HUITT-ZOLLARS

RE: Addison Circle Phase II
Public Infrastructure
HZI Project No. 01-1822-21

RE: Addison Circle Phase I Public Infrastructure
Revised Tree Well Planting in Roundabout
HZI Project No. 01-2013-01

|| Tree Well Planting 'A5'

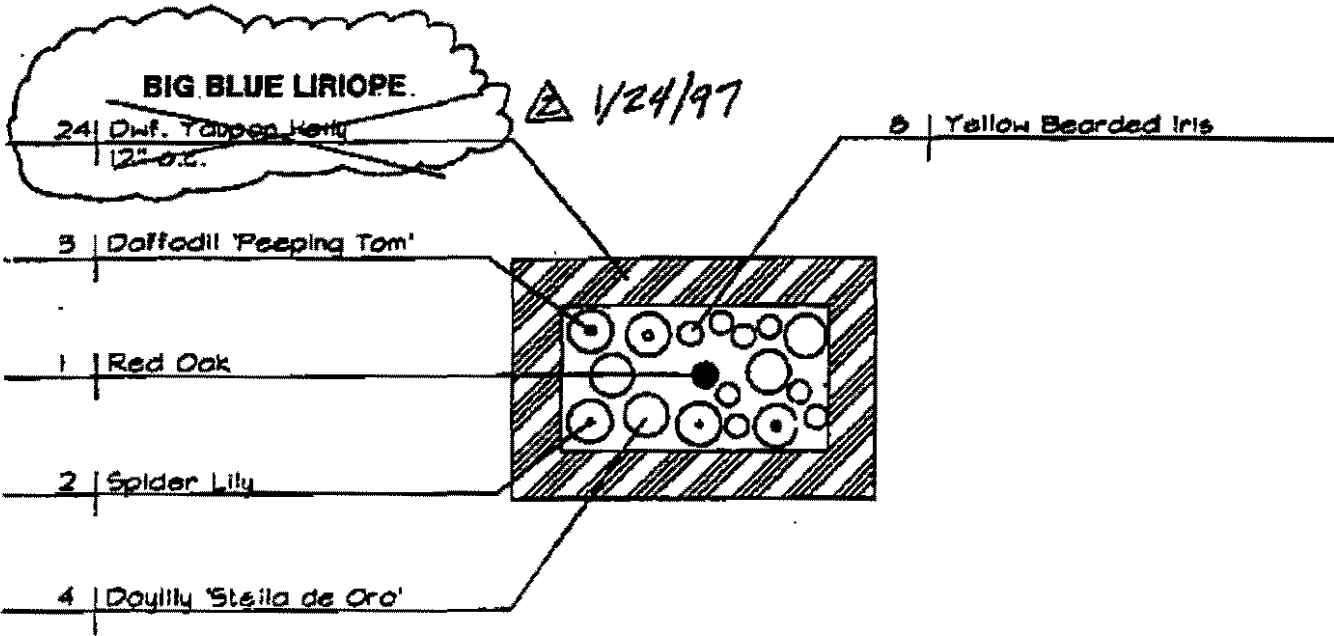
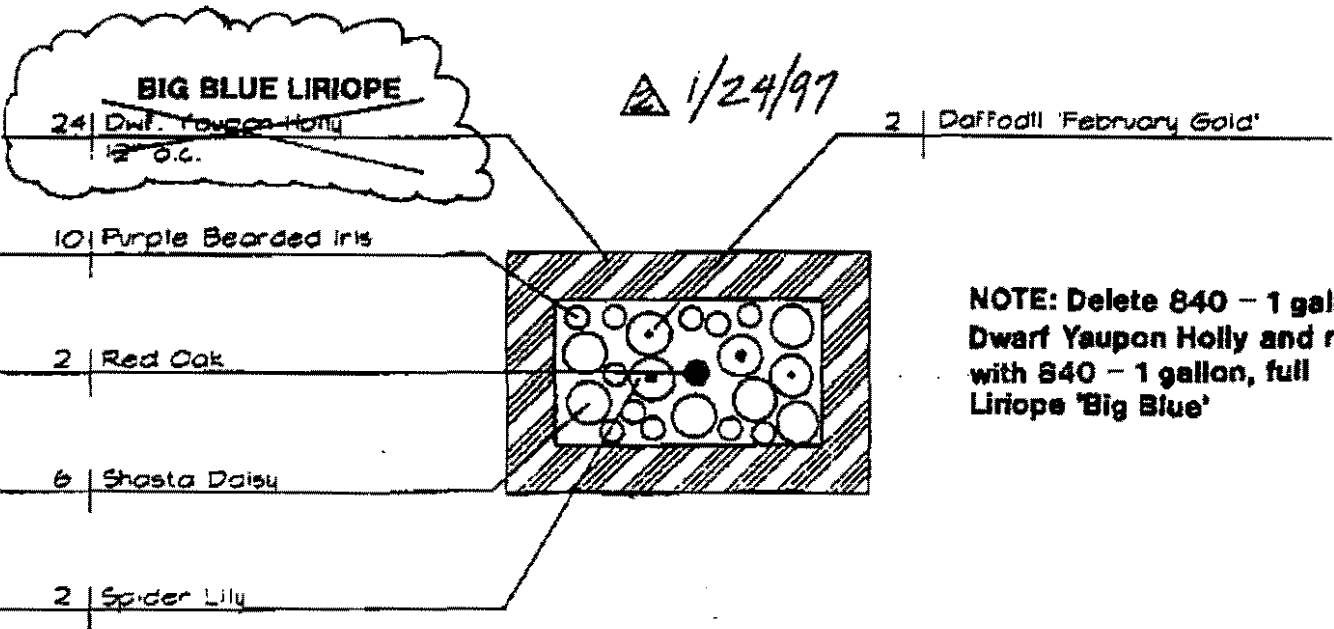
The current contract does not include Big Blue Liriope, therefore we request a change order price for 840 each, furnished and planted, complete in place.

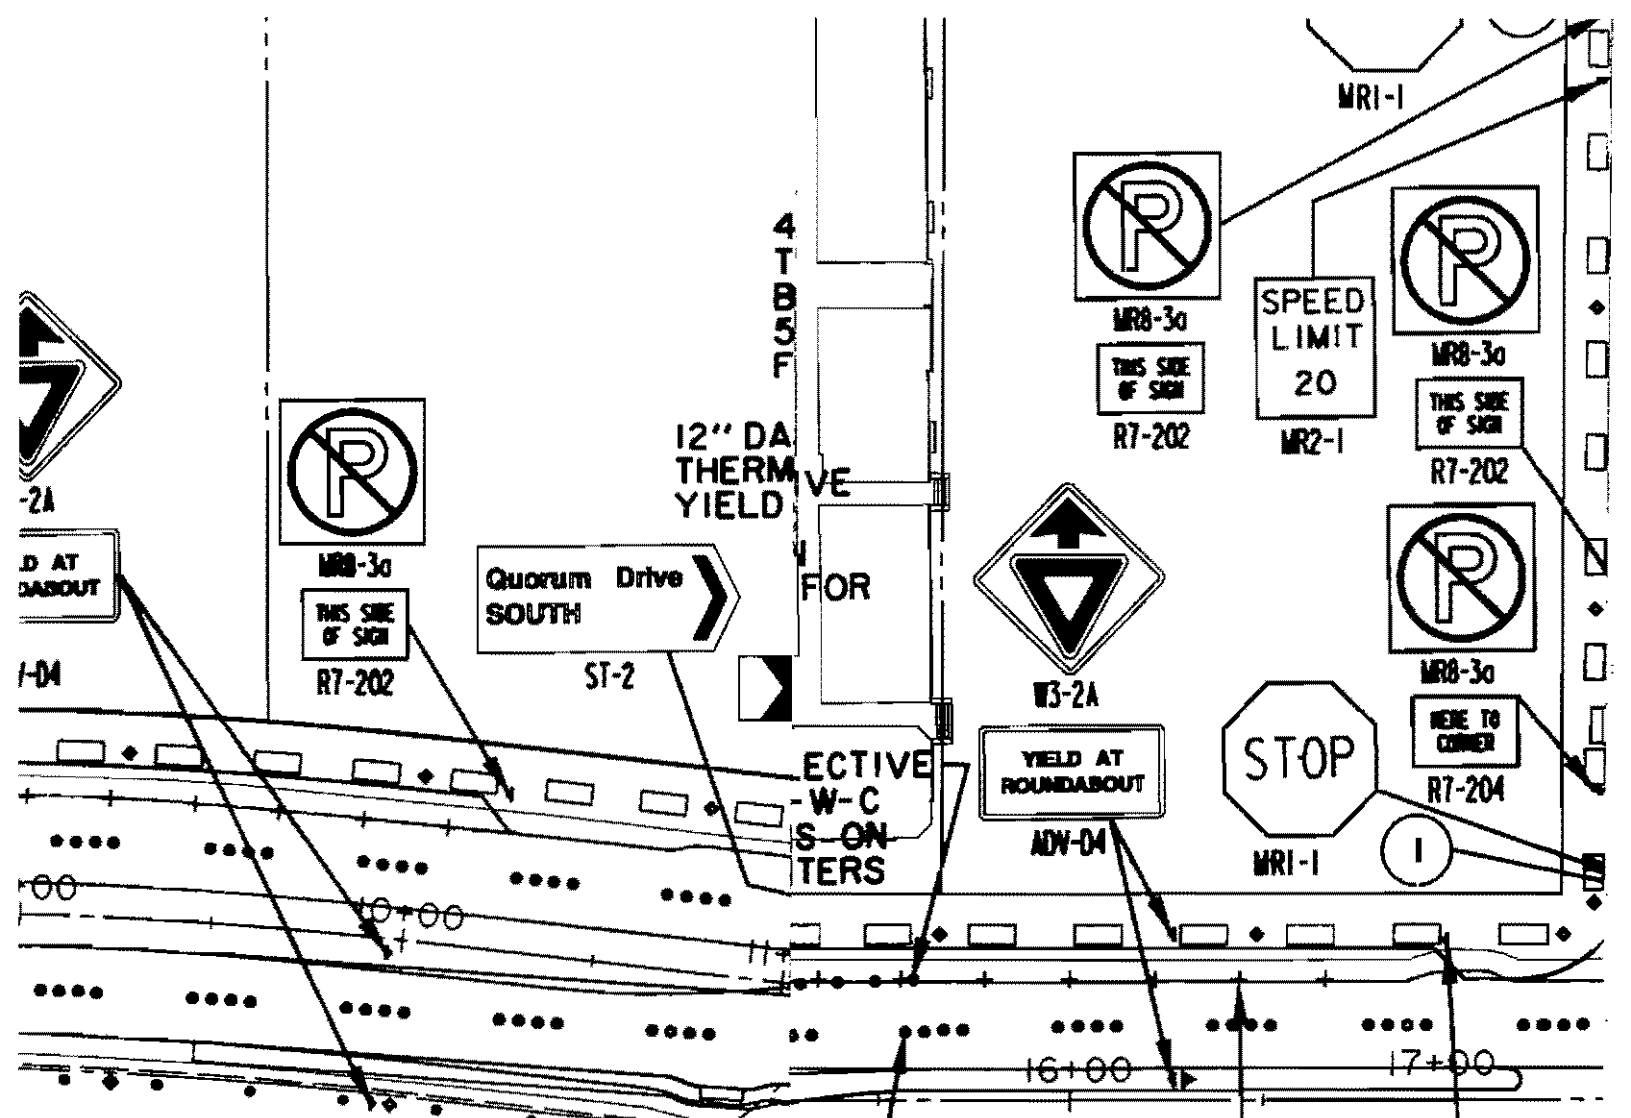
- As noted in a previous memo, the large diagrammatic sign for northbound traffic on Quorum Drive has an error and requires a field revision. The sign should either be modified or covered up before the roundabout is opened to full circular traffic.

- I visited the site on Sunday, February 2, 1997 at around 7:45 p.m. to assess the effectiveness of the reflectivity of the signs and pavement markings. The 30 foot single hood lights around the roundabout and the 30 foot double hooded lights from the railroad to the south side of the roundabout were not operating. This made it very difficult to identify the curbs of the median islands when approaching the roundabout. The lights must be operational before adding any traffic movements to the roundabout. In addition I recommend that we add 4" yellow and white reflective buttons around the median islands to illuminate the curb from a distance. As noted on the following diagram, this would include 48 Type I-Y reflective buttons and 15 Type I-W-C reflective buttons.

REVISED SIDEWALK "LUG" AT STREET

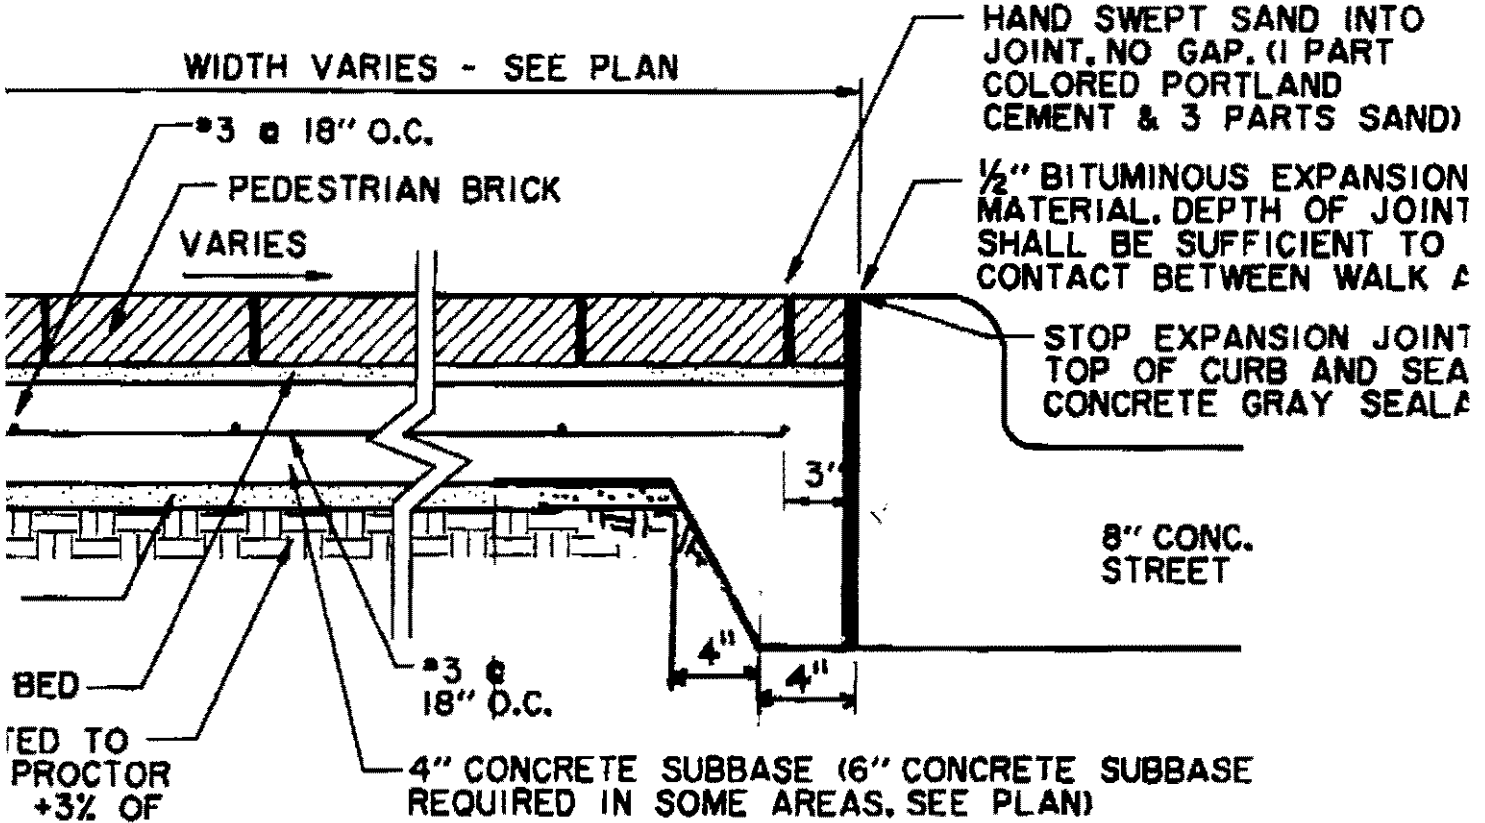
THE FOLLOWING REVISION TO SIDEWALK
"LUG" AS DISCUSSED WITH MYSELF AND
BRUCE ELLIS IS ACCEPTABLE TO
HUITT-ZOLIARS.

EXHIBIT "A"

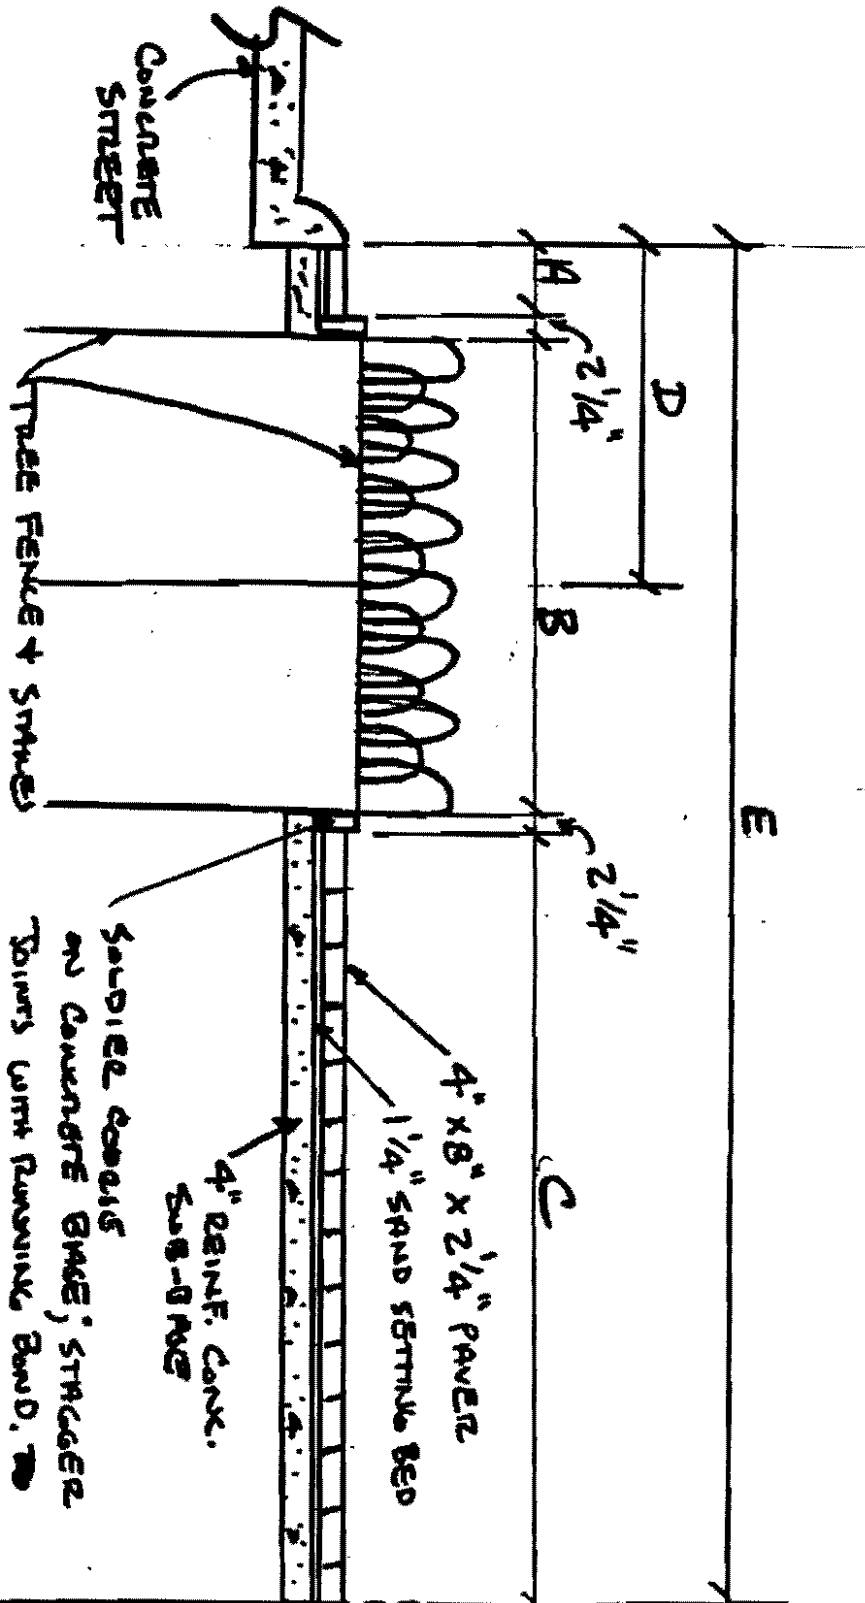
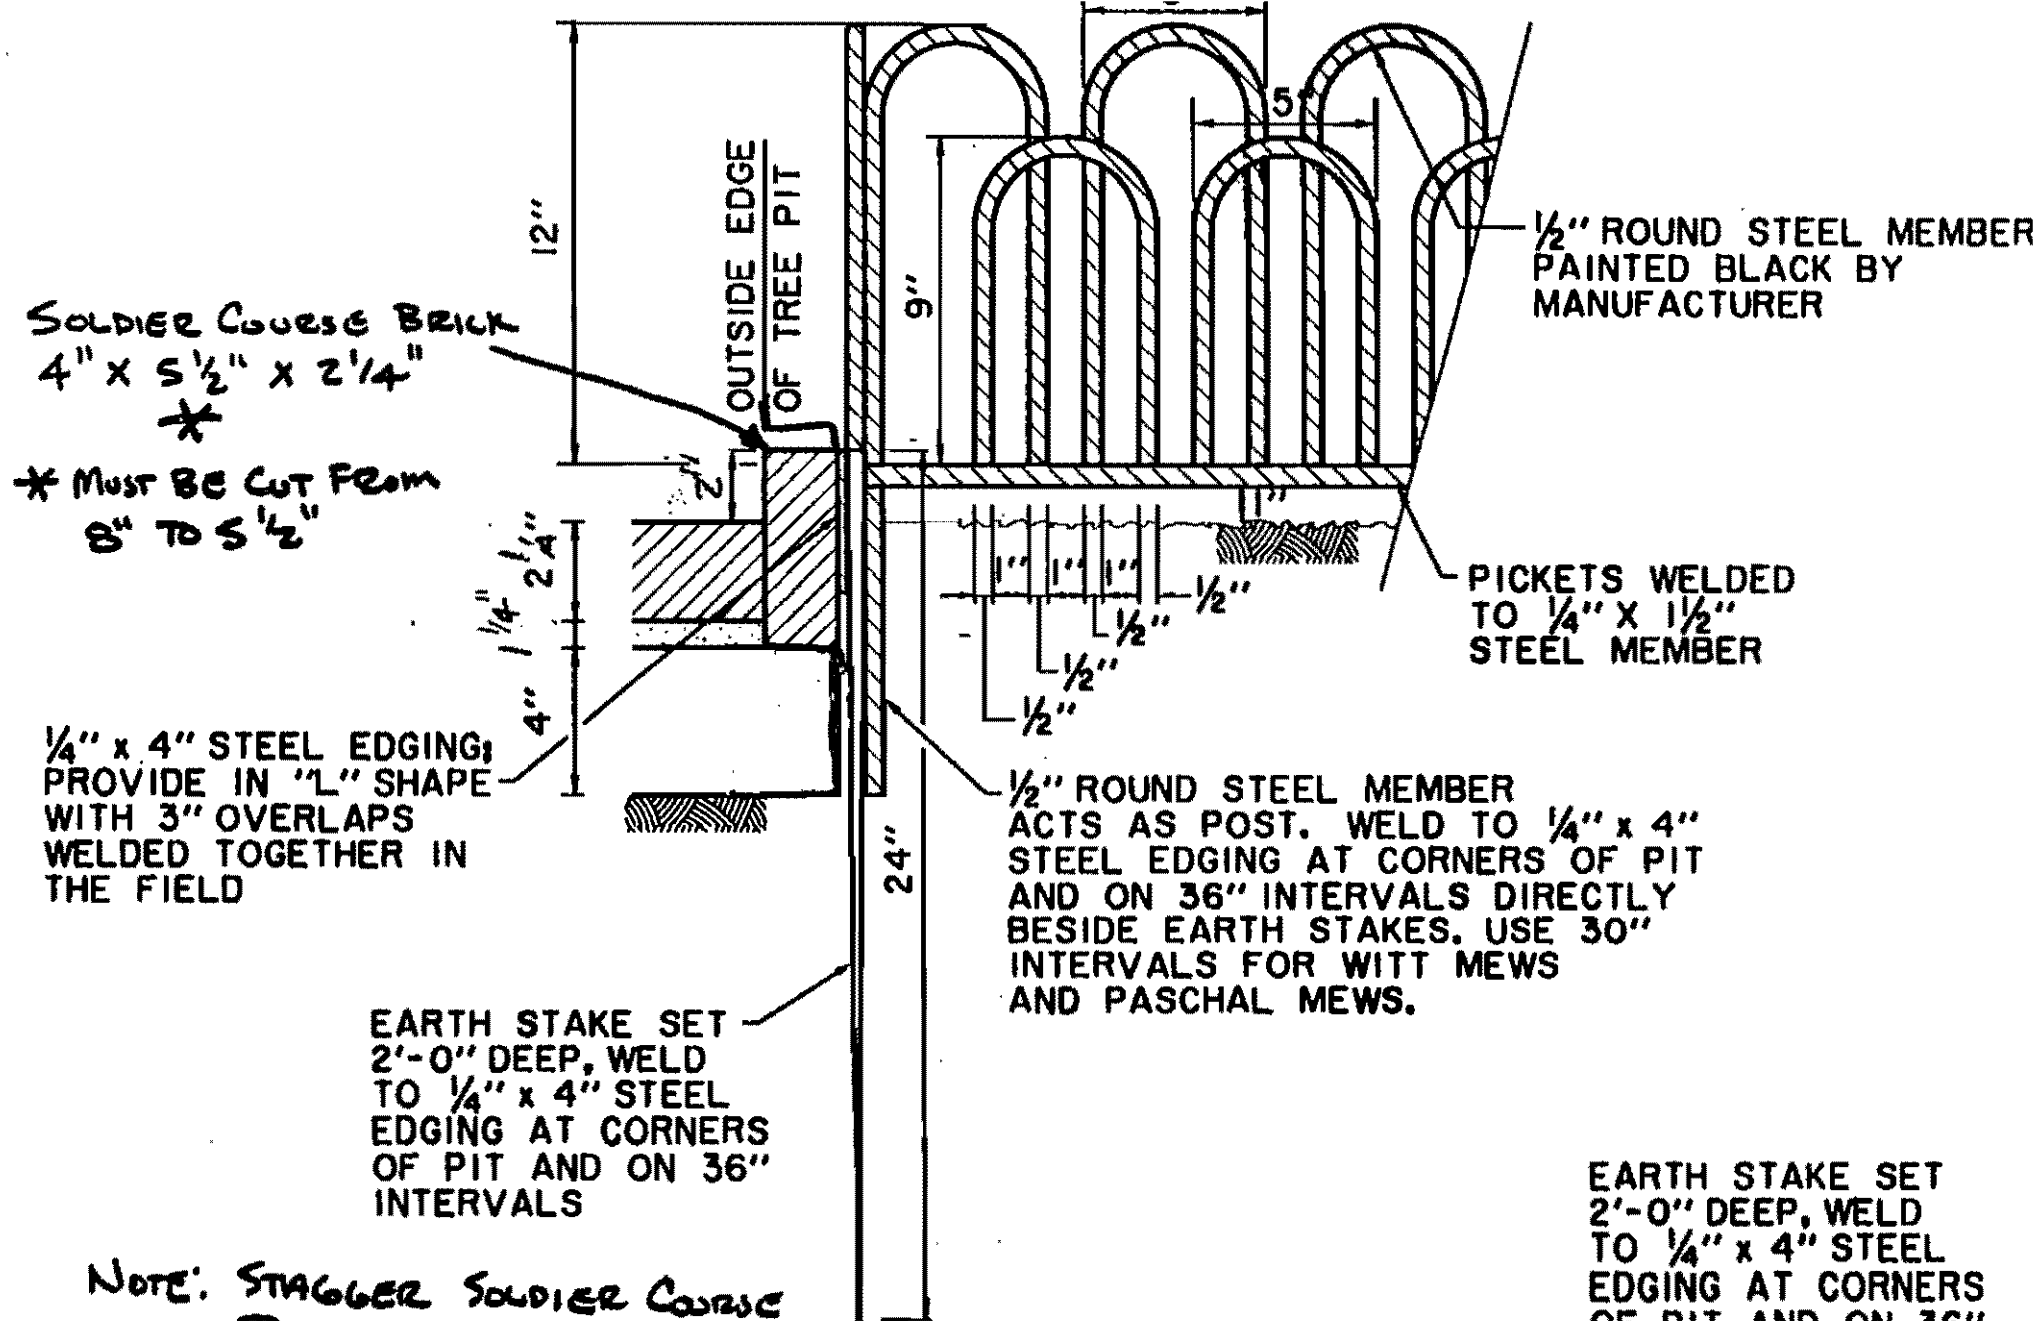
Exhibit "A" illustrates a section through the tree pit for the various streets. The soldier course has been moved outside of the tree pit and the header course has been reduced adjacent to the curb to eliminate the cutting of bricks at that location. We have extended the concrete base under the soldier course to allow the tree fence contractor to set the frame adjacent to your sidewalk sub-base instead of being 2-1/4" inside the concrete sub-base. This should provide a stronger more uniform edge restraint for your brick installation now and in the future when the tree pit is excavated for tree planting. Once the tree is in place the fence will be welded to the frame in the field. Please note that the reduction of the distance adjacent to the curb moves the center of the tree pit to 3'4-1/2" from the back of curb instead of the currently designed 3'-6". The street light foundation should also shift to 3' 4-1/2" in an attempt to maintain the desired alignment with the trees.

EXHIBIT "A"

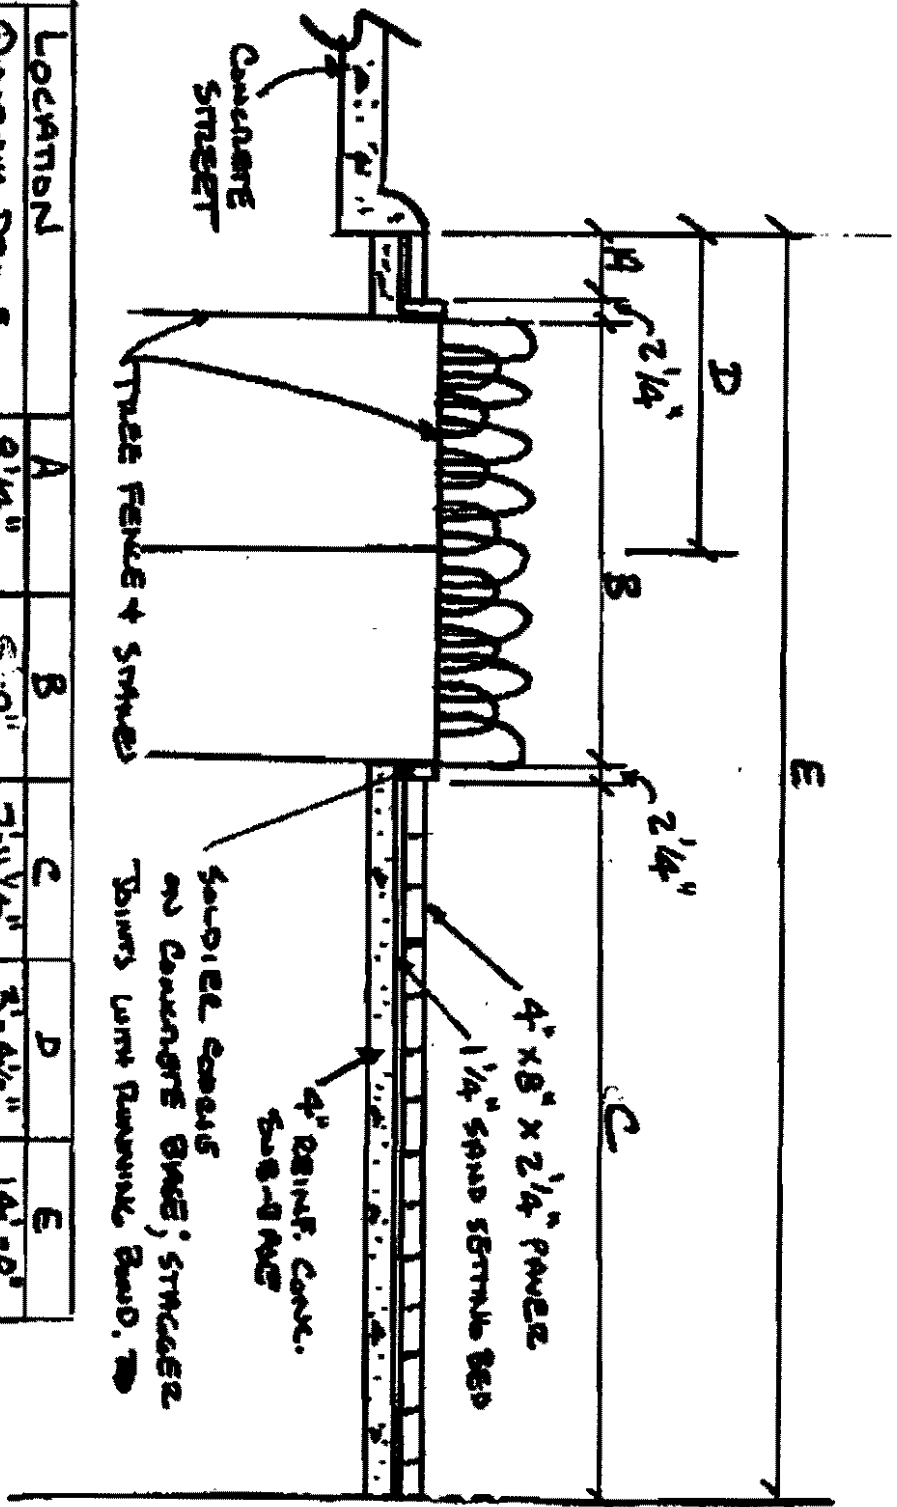
Exhibit "A" illustrates a section through the tree pit for the various streets. The soldier course has been moved outside of the tree pit and the header course has been reduced adjacent to the curb to eliminate the cutting of bricks at that location. We have extended the concrete base under the soldier course to allow the tree fence contractor to set the frame adjacent to your sidewalk sub-base instead of being 2-1/4" inside the concrete sub-base. This should provide a stronger more uniform edge restraint for your brick installation now and in the future when the tree pit is excavated for tree planting. Once the tree is in place the fence will be welded to the frame in the field. Please note that the reduction of the distance adjacent to the curb moves the center of the tree pit to 3'4-1/2" from the back of curb instead of the currently designed 3'-6". The street light foundation should also shift to 3' 4-1/2" in an attempt to maintain the desired alignment with the trees.
